## **RALPH A. AND KIMBERLY S. HARGROVE KRESS** **BUILDING SUBDIVISION**

APPLICATION NUMBER 16 DATE June 19, 2008

## DETAIL SITE PLAN

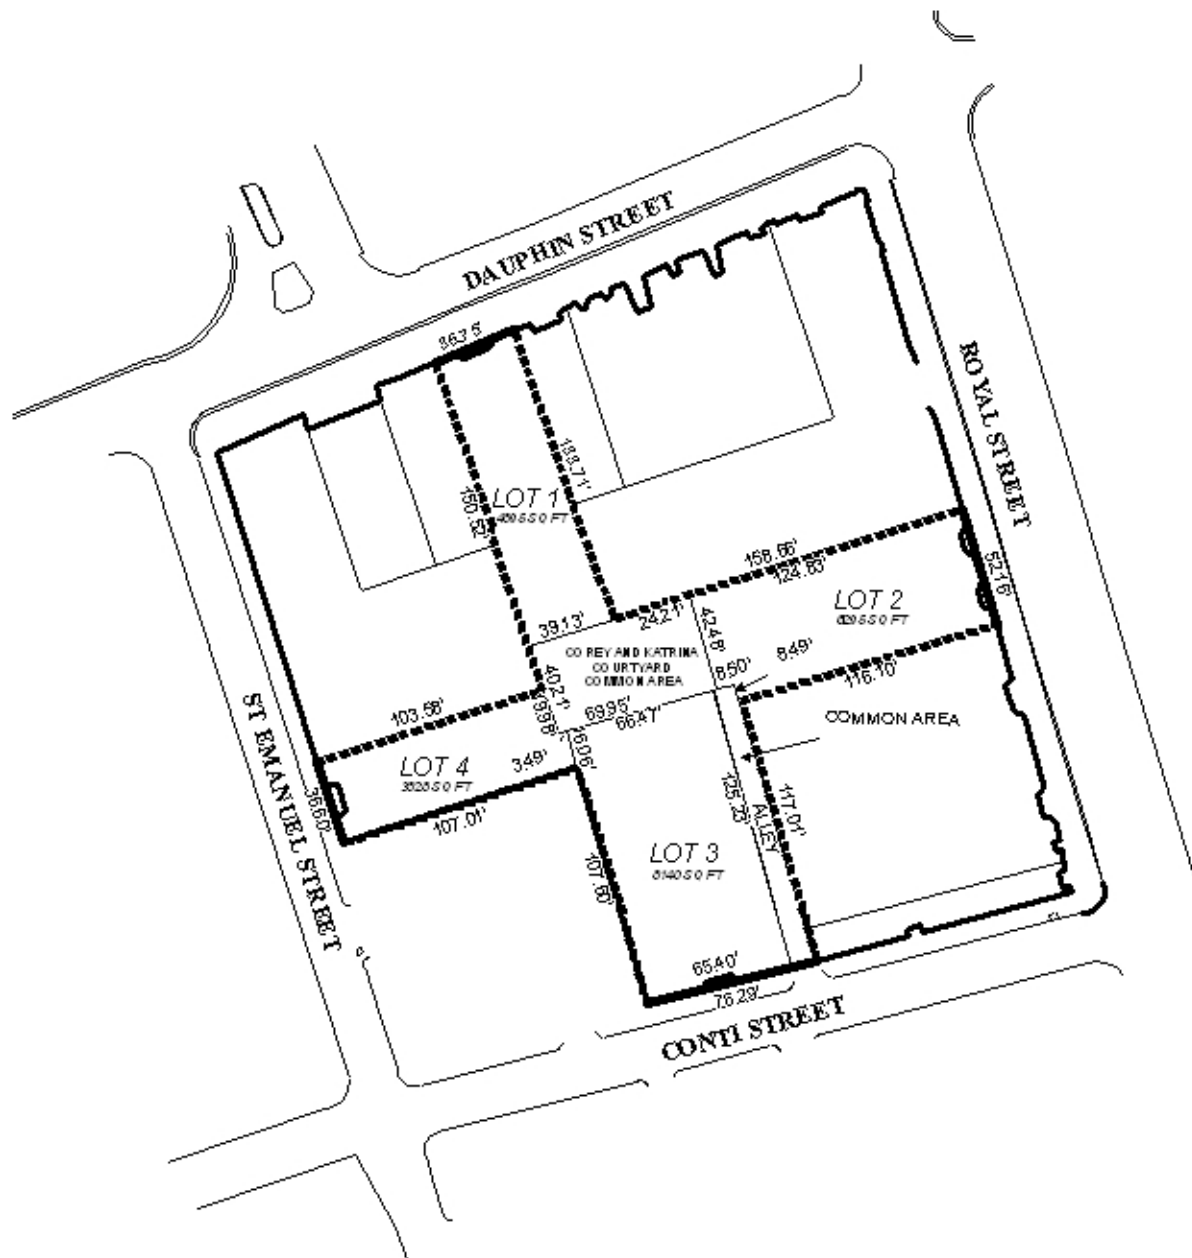
The site fronts onto Royal Street, St. Emanuel Street, Dauphin Street, and Conti Street, all minor streets. No right-of-way widths were provided for any of the streets; therefore, no determination can be made as to whether or not dedication is required. The plat should be revised to indicate the right-of-way widths of all four streets. As the proposed common street access alley opens onto Conti Street, a note should be placed on the final plat stating that the alley is limited to one curb cut, with the size, location and design to be approved by Traffic Engineering and conform to AASHTO standards.

The 25-foot minimum building setback line, required in Section V.D.9., is not shown for the subdivision, however, the site is located in downtown Mobile in a B-4, General Business District, which has no minimum building setback requirements. The setback requirements of the Subdivision Regulations should be waived in favor of those required by the Zoning Ordinance. A note should be placed on the plat stating that there are no minimum building setbacks.

Each lot is labeled with its size in square feet and this should also be done on the final plat, or a table should be provided furnishing the same information.

- 1) revision of the plat to indicate that the central courtyard common area is open-air with no floor or roof above;
- 2) revision of the plat to indicate the right-of-way widths of all four fronting streets; and
- 3) submission of a Planned Unit Development application to address the shared access to the common areas.
